METROPOLITAN GOVERNMENT OF NASHVILLE AND DAVIDSON COUNTY

STAFF RECOMMENDATION
1616 Forrest Avenue
October 16, 2013

Application: Demolition; New Construction - Infill and Outbuilding
District: Lockeland Springs-East End Neighborhood Conservation Zoning Overlay
Council District: 06
Map and Parcel Number: 08310018100
Applicant: Jeremy Bockman, Developer
Project Lead: Sean Alexander, sean.alexander@nashville.gov

1616 Forrest, existing structure.

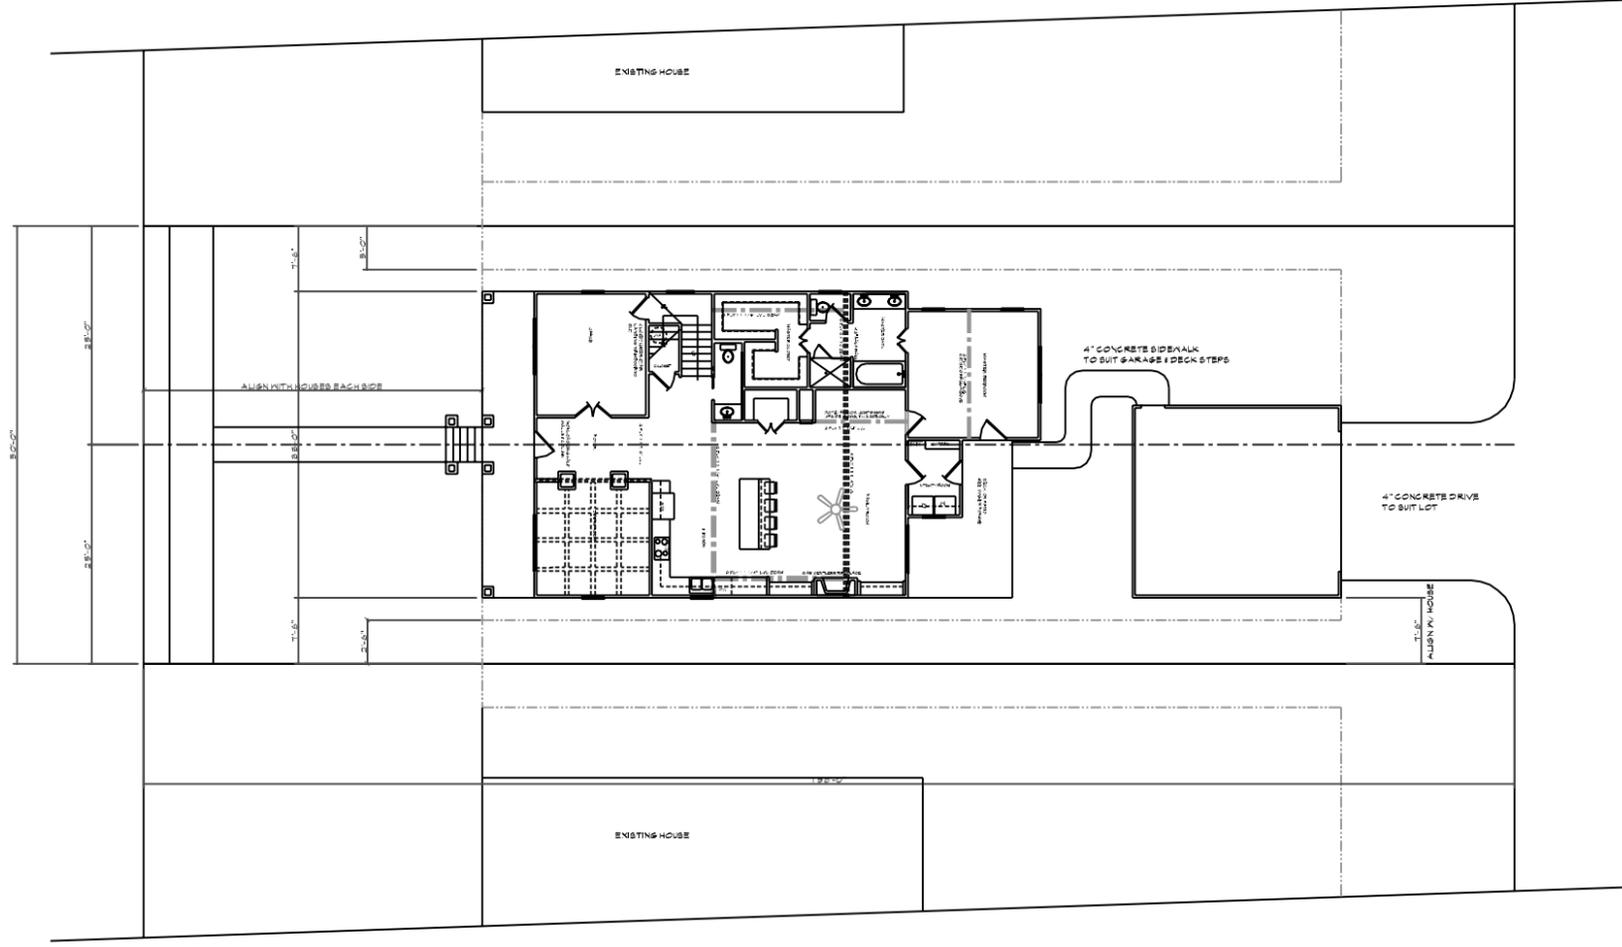
Background: The house at 1616 Forrest Avenue is a one-story Minimal Traditional style house, constructed circa 1950. Due to its recent date of construction it has not acquired historic status, and therefore is considered not to be contributing to the character of the district.

The existing structure does not contribute to the historic character of the overlay.

The application to demolish the structure meets section III.B.2 for appropriate demolition and does not meet section III.B.1 for inappropriate demolition.

Scale:	1/4" = 1'-0"	Drawing Number	S-1	Rev. No.	0
SITE PLAN

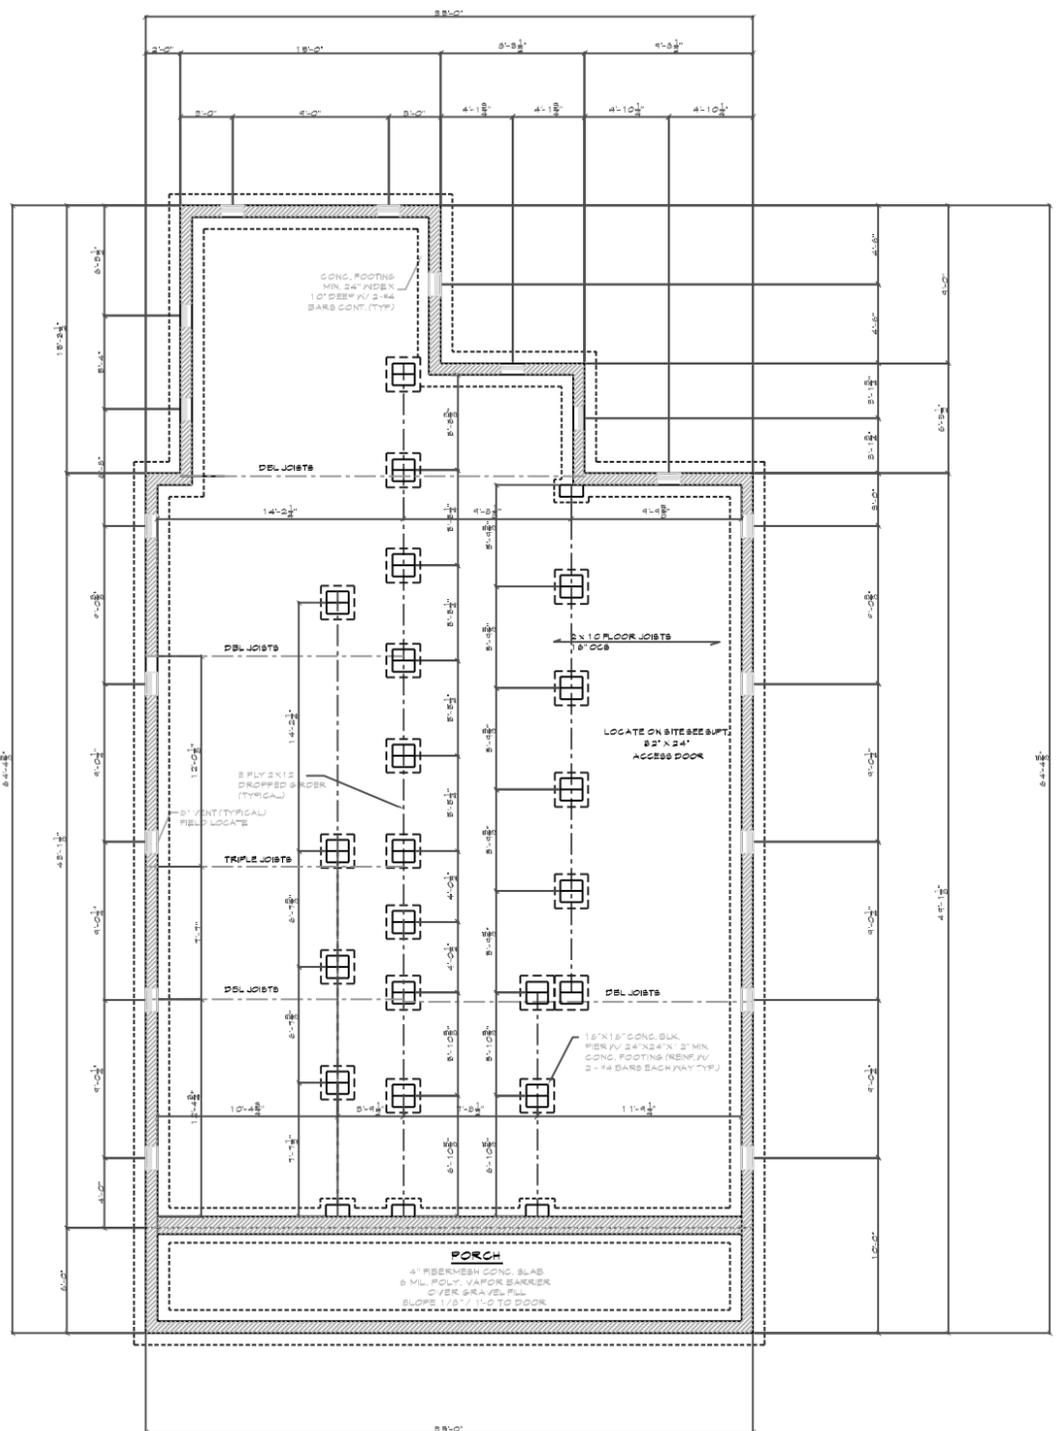
The site plan notes that the front setback will be in alignment with the homes on either side. The side setbacks will be approximately seven feet (7') on each side, which is compatible with the setbacks of surrounding historic houses and meets the minimum bulk zoning requirement of a minimum of five feet (5').

The house will be oriented to address the street in the same manner as surrounding houses with a primary entrance facing Forrest Avenue and concrete walkway leading from the front steps to the sidewalk. The vehicular access will be at the rear of the property, off the alley.

Staff finds that the setbacks and orientation are appropriate because they will maintain the established rhythm of the street, and meet guidelines II.B.3. and II.B.6.

FRONT & REAR ELEVATIONS

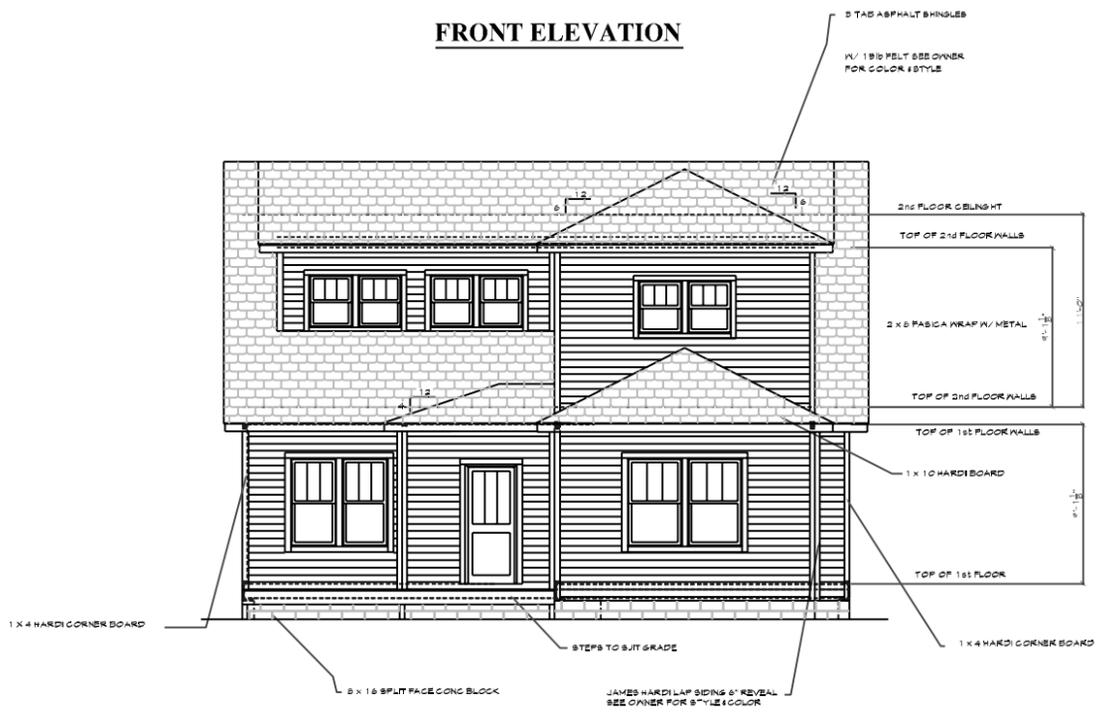
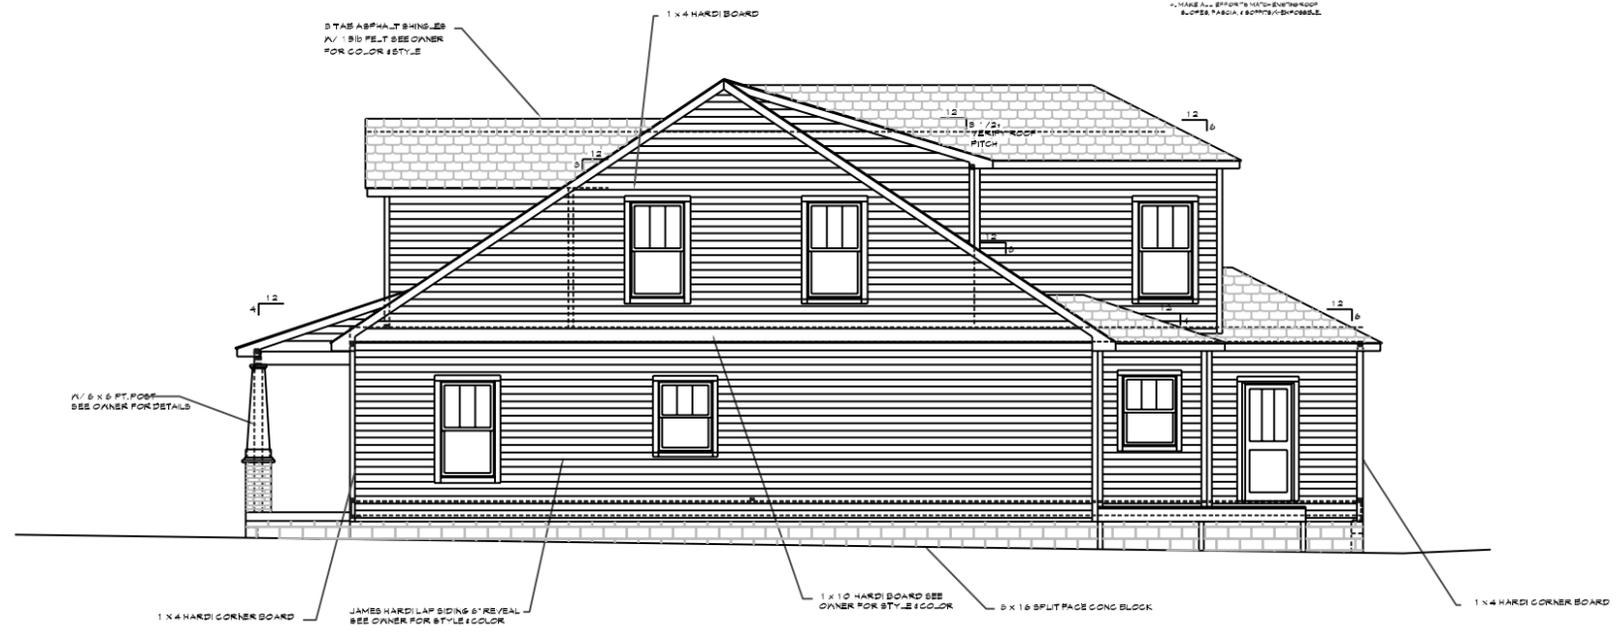
The new house will be one and one-half stories tall with a form similar to that of a side-gabled Craftsman bungalow, a common house-type for the area. The house will have a foundation height of approximately two feet (2') and an eave height of approximately nine feet (9') from finished floor, and ridge height of approximately twenty-four feet (24') from finished floor. Historic structures in the immediate context range between sixteen and twenty-eight feet (16'-28') from grade.

The house will be thirty-five feet (35') wide across the front. The depth of the house will be sixty-one feet (61') including a six foot (6') deep front porch. Historic structures in the immediate vicinity range between approximately thirty and thirty seven feet (30'-37') wide.

The foundation will be split-face concrete block, the cladding a smooth-faced fiber-cement siding with a five inch (5”) exposure and the roof asphalt shingle roof in a “weathered wood” color. The exterior trim will be cement-fiber. The windows and doors will be wood. The materials for the porch columns and porch floor are not indicated. With the condition that those materials are approved by Staff, these materials meet guideline II.B.4.

Roof form: The primary roof, a side-oriented gable, will have a pitch of 8:12, as will the front gabled dormer. These roofs are compatible with those of historic houses nearby and meet guideline II.B.5.

The front elevation will have a typical Craftsman window pattern with three-over-one windows. The majority of windows are twice as tall as they are wide, which matches the proportion of windows on historic homes in the district. The rhythm of window openings will also be similar to a Craftsman style. The longest expanse without an opening is approximately twenty-feet (20’); however, this takes place beyond the midpoint of the house where it will have a minimal visual impact. Staff finds the window rhythm to meet guideline II.B.7.

Staff finds the height and scale to be compatible with the surrounding buildings and to meet guidelines II.B.1 and II.B.2.

22'-0" X 24'-0" DETACHED GARAGE
SINGLE STORY

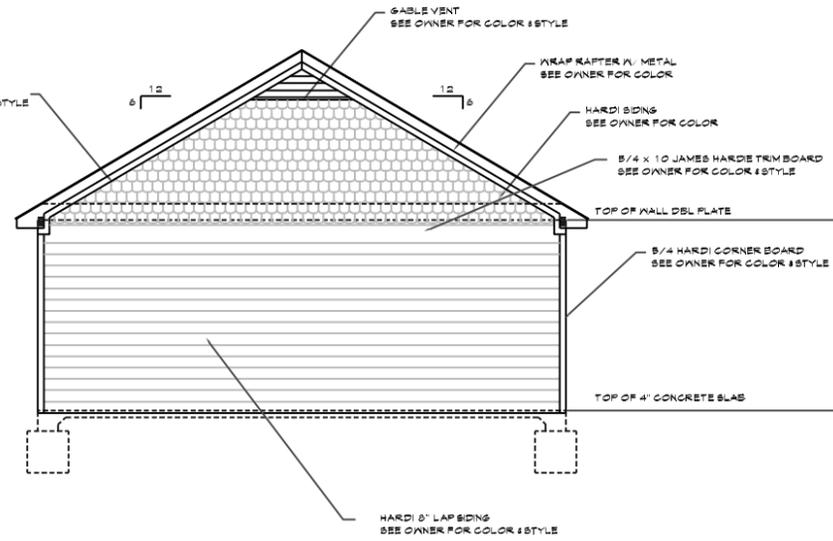
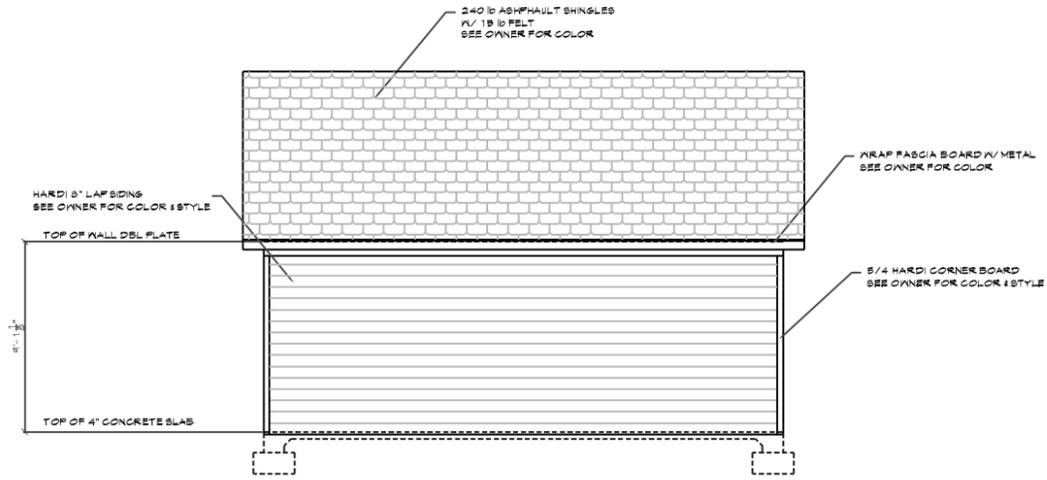
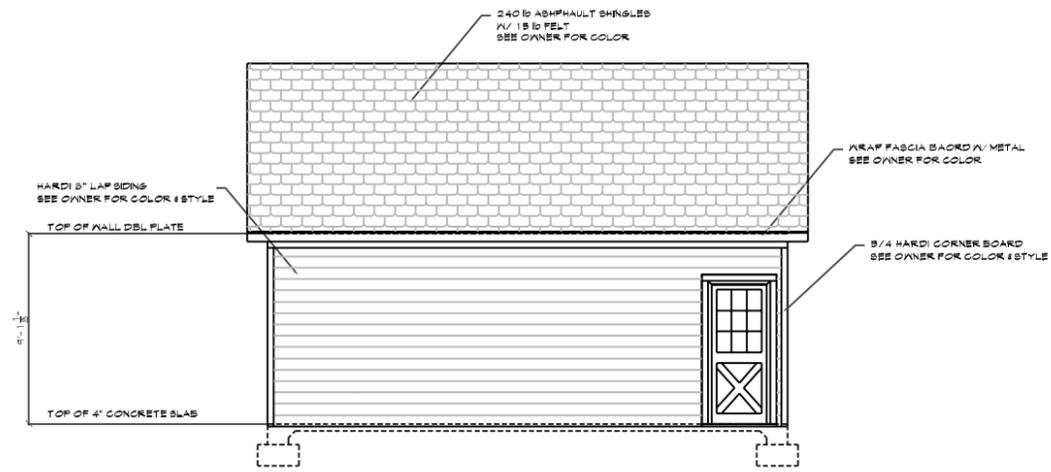
The outbuilding will be a one story, two-car garage with an area of five hundred, twenty-eight square feet (528 sq. ft.). The building will be eighteen feet (18’) tall with a gabled roof. The materials of the outbuilding will match those of the new house. The building will be located behind the primary building and will be accessed from the alley.

The project meets section II.B.8 of the design guidelines.
